Watts Bar Nuclear Plant Unit 1
Facility Operating License No. NPF-90
NRC Docket No. 50-390

Subject: **Response to NRC Request for Additional Information Related to License Amendment Request to Updated Final Safety Analysis Report Changes Associated with Hydrologic Analysis (TAC No. ME9130)**

RESPONSE TO NRC BALANCE-OF-PLANT BRANCH (SBPB) REQUEST FOR ADDITIONAL INFORMATION (RAI)

PIC 60484
PG 46

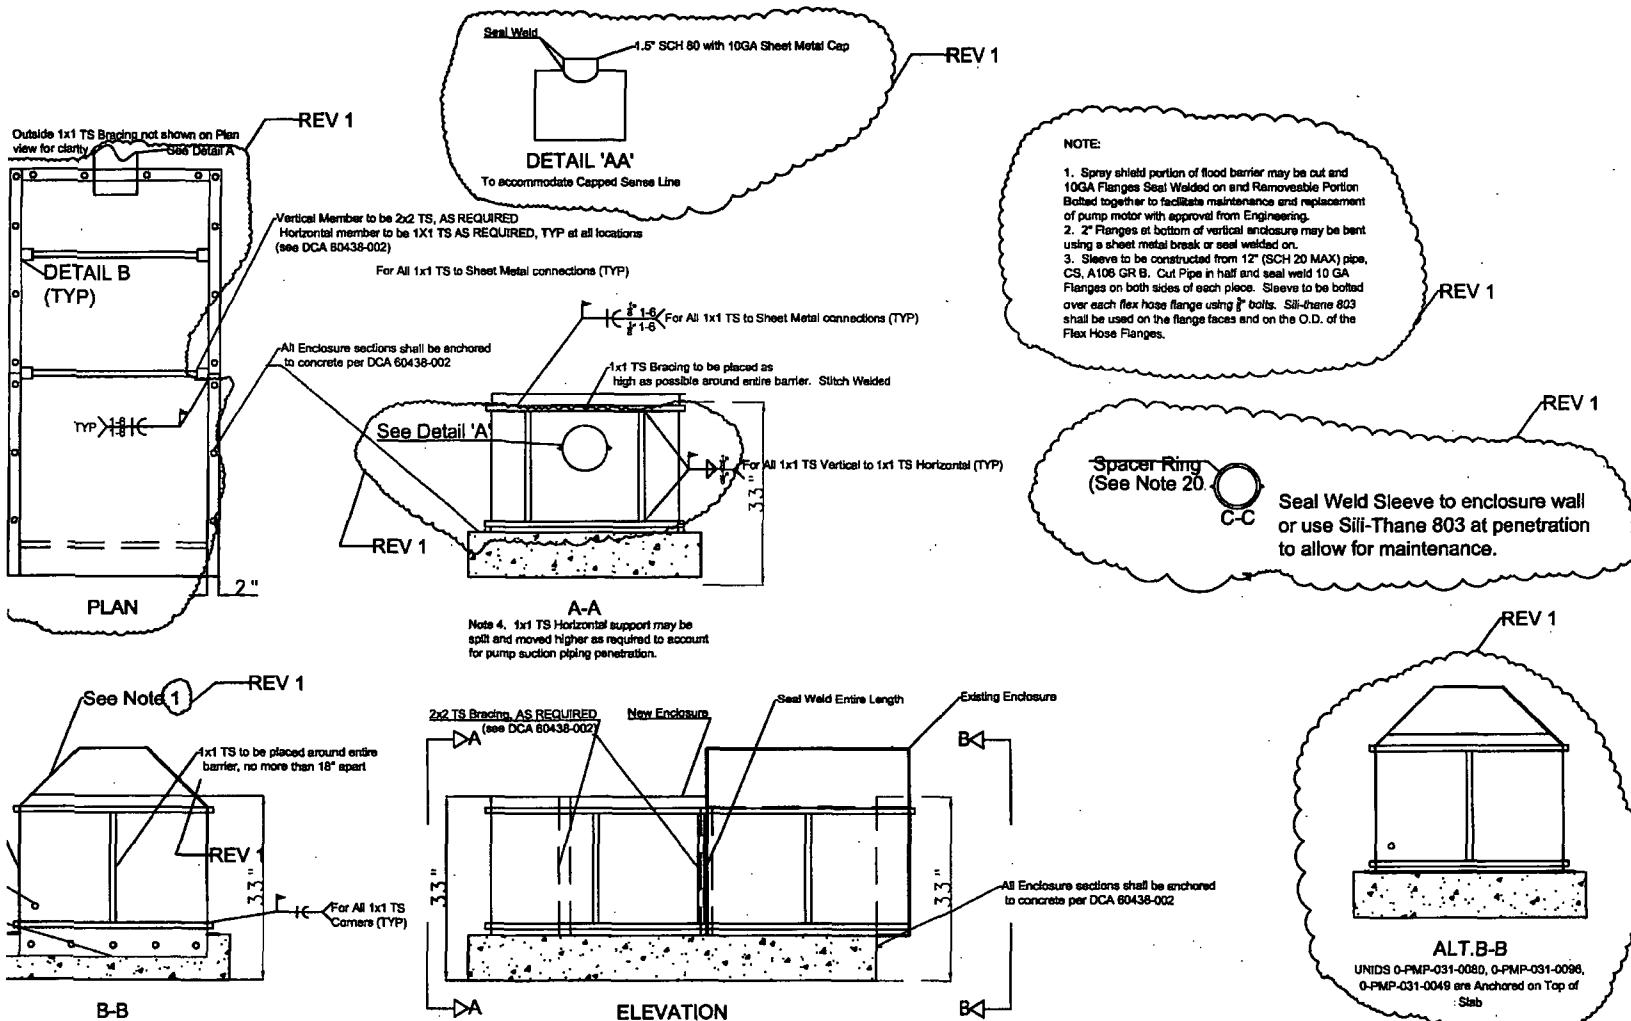
Please provide diagram(s) for the planned plant modification to provide flood barrier around the MCR and SDBR chilled water circulating pumps and motors, and to protect the affected MCR and SDBR Chiller ancillary equipment from water intrusion.

- a) Please clarify if the flood barrier will have to be removed in its entirety during maintenance, replacement, and installation of the submersible pump.
- b) Will the flood barrier need to be removed for maintenance or replacement of the drain line manual valve?
- c) What is the timeframe for removal and re-installation of the flood barrier during these activities?

Permanent flood protection barriers have been installed for the MCR and SDBR Chillers, and ancillary equipment, located on Auxiliary Building floor elevation 737.0 ft, to provide protection for these components up to the DBF surge elevation within the Auxiliary Building (739.7 ft). The drawings for the flood barrier around the MCR and SDBR chilled water circulating pump are provided in Attachment 1.

- a) No part of the flood barrier constructed around the MCR and SDBR chilled water circulating pumps would have to be removed during installation of the submersible pump. Replacement or maintenance on the chilled water circulating pump motor would require removal of the spray shield incorporated into the flood barrier design as shown in Attachment 1.

- b) The flood barrier constructed around the MCR and SDBR chilled water circulating pumps would not require removal for maintenance or replacement of the drain line manual valve. The drain line valve threads onto a threaded pipe segment that is seal-welded to the flood barrier as shown in Attachment 1.

- c) Removal and re-installation of the spray shield on the flood barrier can be accomplished in less than an hour. Removal involves removing a series of bolts along the top sides of the flood barrier, and installation involves refastening of the bolts. Without the spray shield on, the pump motors would be exposed to potential spray from a fire protection actuation or process fluid line break, but would still be protected from an external flood event.
